ADDENDUM No. 03

Shalimar Elementary School Cafeteria Renovation

October 7th, 2026

ARCHITECT – Heffernan Holland Morgan Architecture

SH-A1

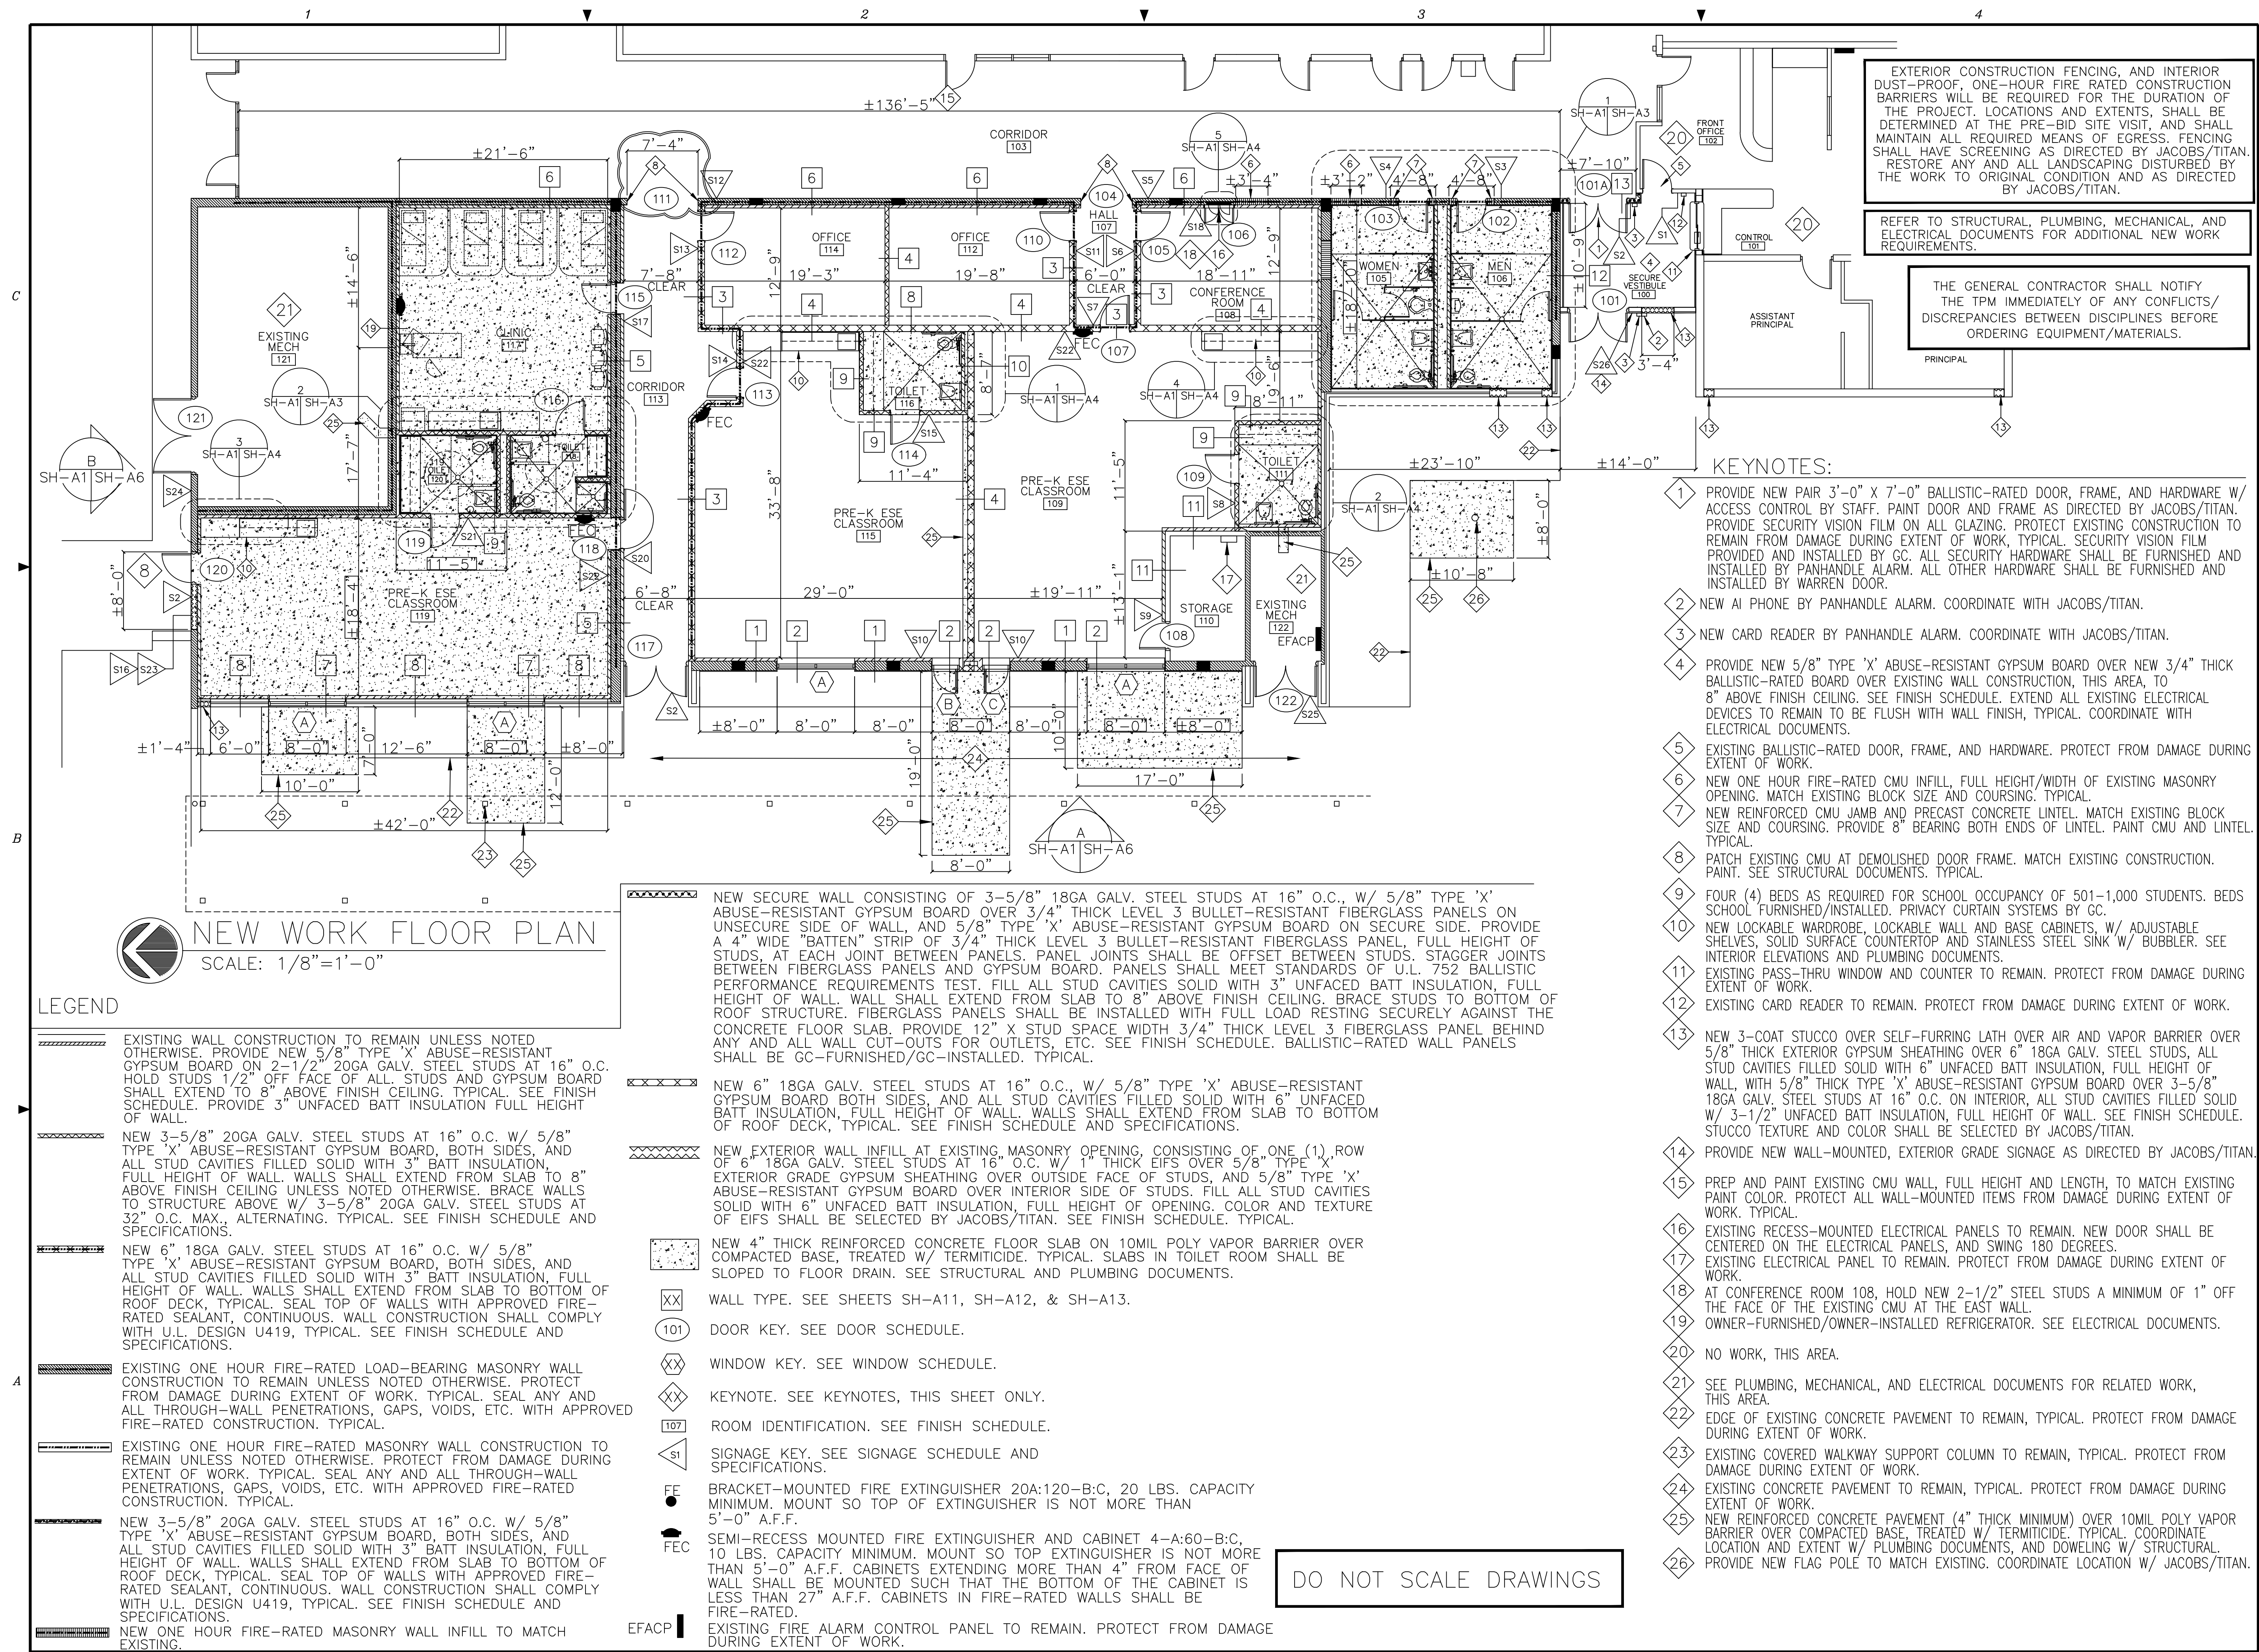
2. **REF:** Sheet SH-A1

Question: On Addendum 2, the revised floor plan sheet SH-A1 has two openings that no longer have a mark # showing; existing mech room 122 and toilet room 118. The door schedule on sheet SH-A8 still looks unchanged for the scheduled openings, only a glass note was marked differently. Were any openings changed to existing to remain or deleted?

Answer: There is no change to door openings. The Floor Plan has been corrected to include the missing door numbers and the revised Sheet SH-A1 attached.

Designed By:	JEF	Drawing No.: SH-A8
Drawn By:	JEF	
Checked By:	PDM

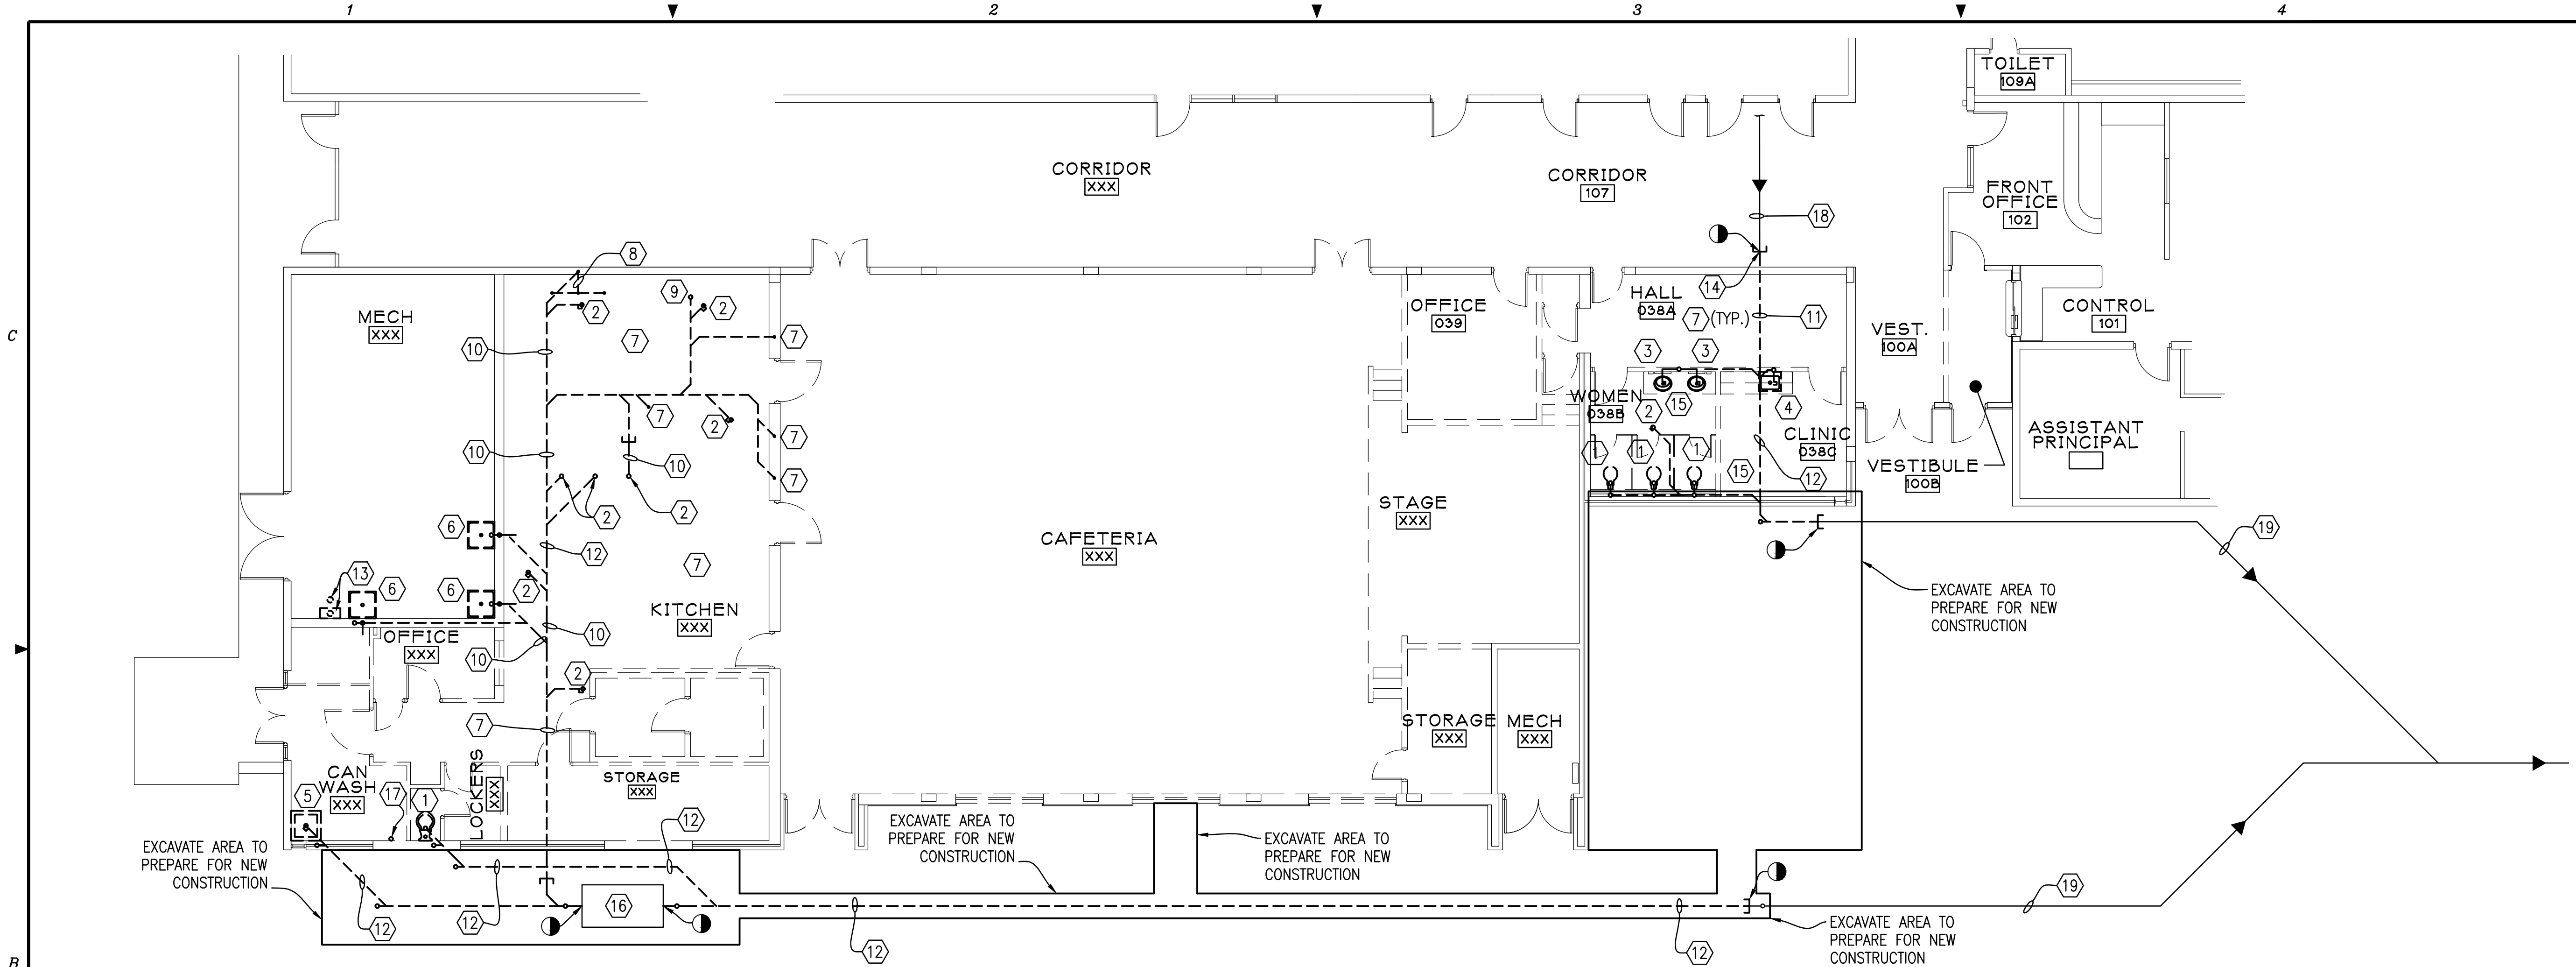
3. **REF:** Sheet SH-A8

Question: The revised Sheet A-8 dated 9/23/26 – Door Schedule – Doors 102 & 103 still indication Details 11 & 12 on Sheet A10. Sheet A10 does not have details 11 & 12 – Please provide details or do we use the details 10 & 11 as shown on Sheet SH-A9.

4. **REF:** Sheet SH-A8

Question: The bullet resistant pair at the vestibule is specified by one manufacturer (Republic). This opening is shown to be 20 min fire rated but this manufacturer doesn't have a level 3 BR door with any fire rating.

5. **REF:** Sheet SH-A8

Question: Set# 9 has storage function in the description with a lockset and it also has a removable mullion. Typically, a removable mullion would be used with rim exit devices. The hurricane tested configuration we are pricing for this door would include surface bolts and an astragal for the inactive leaf when used with a mortise or cylindrical lock on the active. It does not state which type of lockset; we will price a cylindrical lock as used on most of the other openings that do not have exit devices. shall we omit the mullion?

6. **REF:** Sheet SH-A8

Question: Some of the sets describe the lock cylinder as "intruder function" but the lock or exit devices do not reference the necessary model information to suggest intruder function. A lock core/cylinder does not carry the functionality on its own. Should some of the locksets be intruder function or should this be disregarded? An intruder function lock has a lock cylinder on both sides. A classroom function has a lock cylinder on one side.

Answer: Use door Details shown on Drawing Sheet A-9. See revised Sheet SH-A8 Door Schedule attached.

Answer: See updated Sheet SH-A8 Door Schedule. There is no longer a requirement for the Level 3 Door to be fire rated.

Answer: We have deleted the mullion and indicated two flush bolts (top & bottom), and astragal. Lockset function is Storage-Keyed from outside, inside always active. See new Sheet SH-A8 Door Schedule attached.

Answer: Provide intruder function on all doors specified with Hardware Set #2.

SH-E9

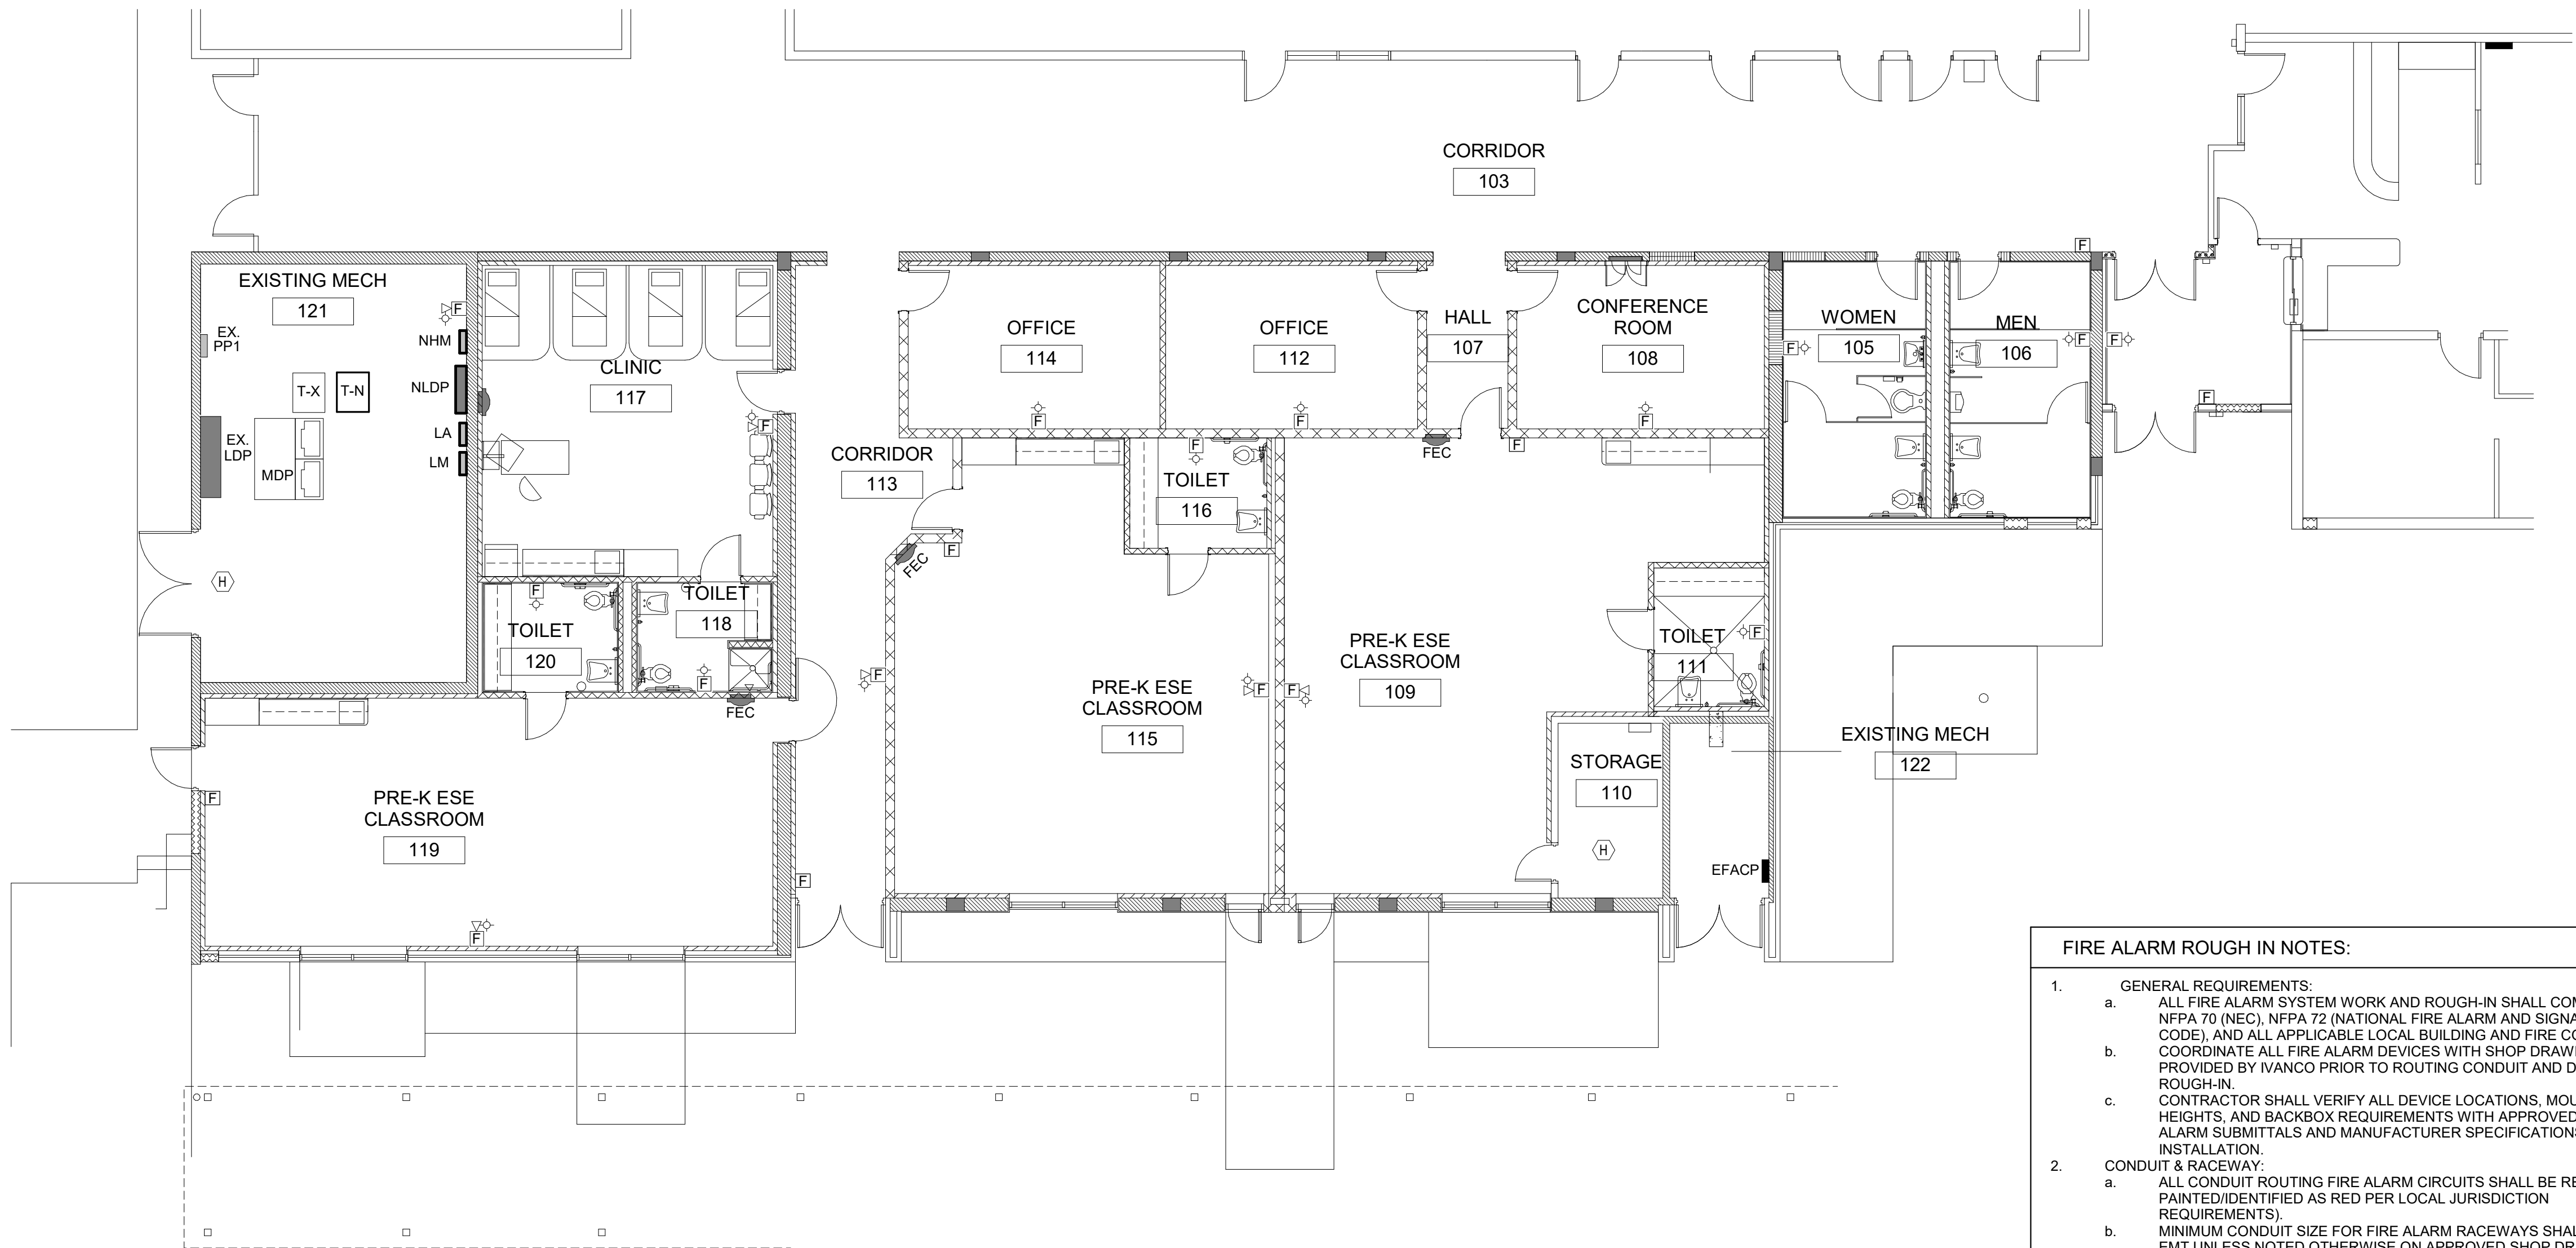
9. **REF:** Sheet SH-E9
Question: There is no new Fire alarm work shown on the E sheets? The only thing shown is on page SH-LS1. The rough and electrical requirements for the fire alarm system need to be shown on the Electrical drawings or the System Sheets, if it is to be provided by the electricians.
Answer: See new attached Sheet SH-A9 for rough in requirements. Locations of pull stations, horn / strobes, and heat detectors will be more in line with what is shown on Sheet SH-LS1.
